APPENDIX A. RESPONSE TO LRD OPINION

Please refer to the submitted Thornton O'Connor's Planning Report for the complete response to the LRD opinion. Commentary regarding Architectural and Urban Design items are provided below:

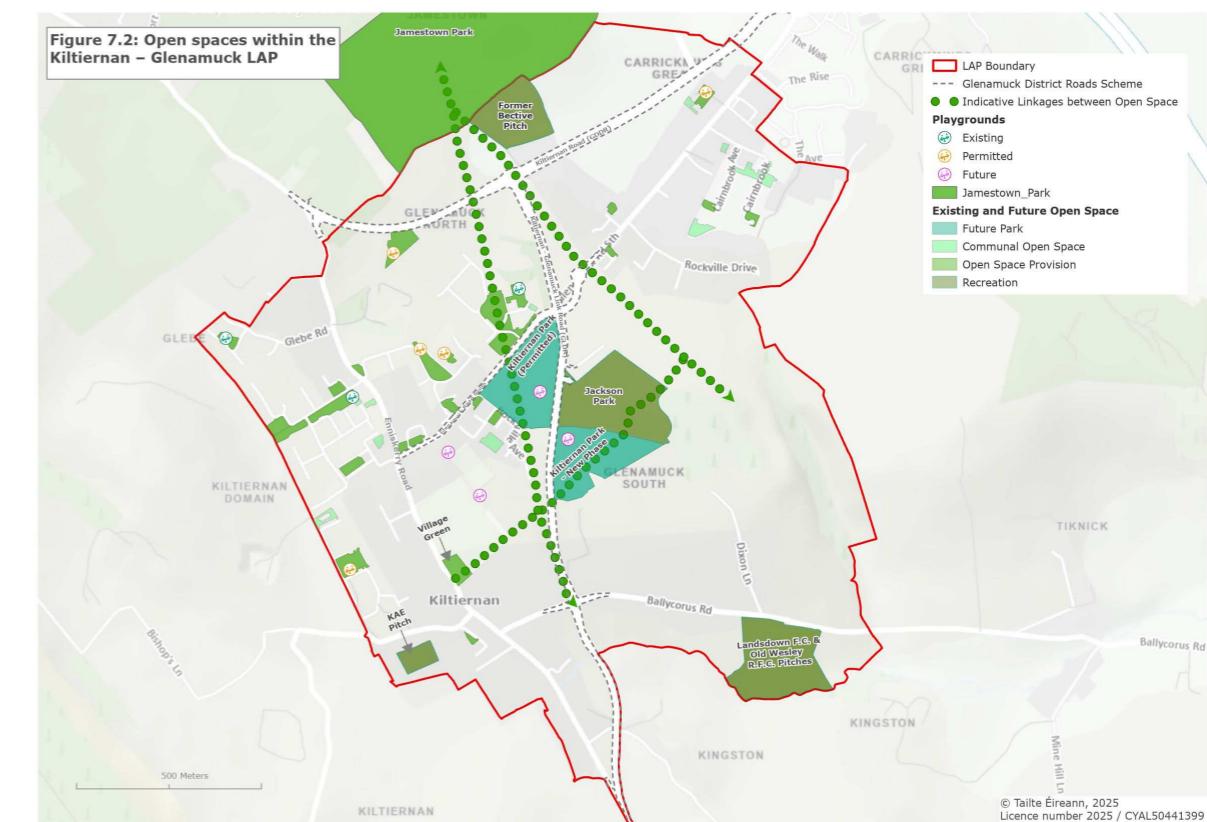
The Planning Authority recognises the constraints faced by the applicant with powerlines crossing the site. The planning authority note that the powerlines impact on the layout of the site and how the scheme successfully addresses the GDDR and GLDR on the current site and the northern site. The applicant is requested to review the approach taken to the issue of Public Open Space on nearby sites under the same 220kv lines as regards the extent to which these areas can be considered part of the public open space provision for the site, or must be counted as additional open space.

RESPONSE: We note that a precedent has been set in the nearby sites of Rockville and Kiltiernan Village with the open spaces beneath the 220kv power lines in each scheme. The open space in the subject site comprises various different uses, casual play, formal play and pedestrian routes. There is also a quantum of open space to the western side of the site which is not in the riparian corridor. We have also proposed a significant over provision of Communal open space, approximately 3 times the required quantum.

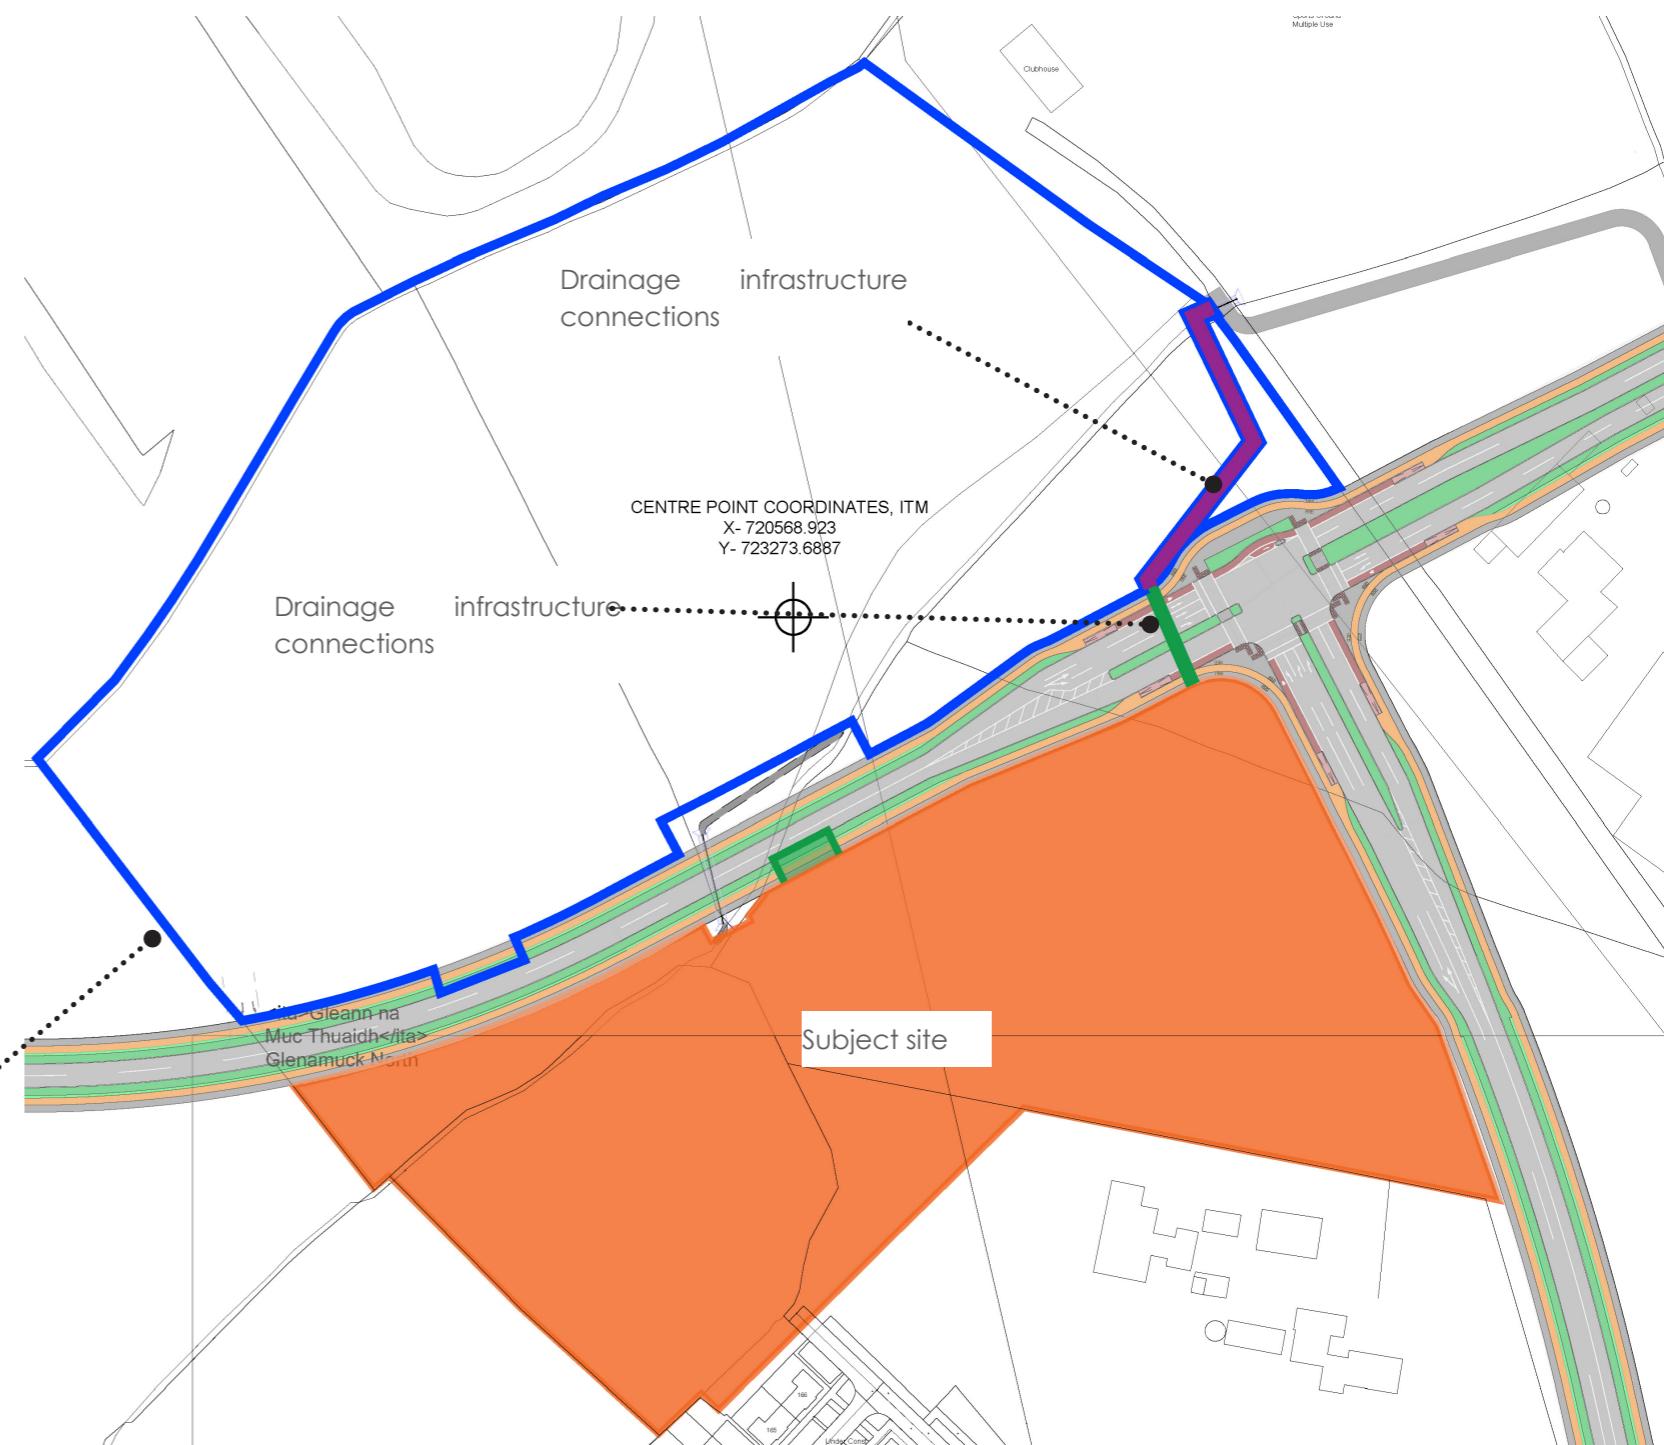
The applicant is requested to provide details of how the current and the northern site are to be linked ie. Clarity on the red and blue lines, include details of shared services / infrastructure proposals.

RESPONSE: Please refer to the Site Location maps included in the planning submission, drawings AR1005-1006 for red and blue lines. Please refer to RMA drawings for further details on shared infrastructure
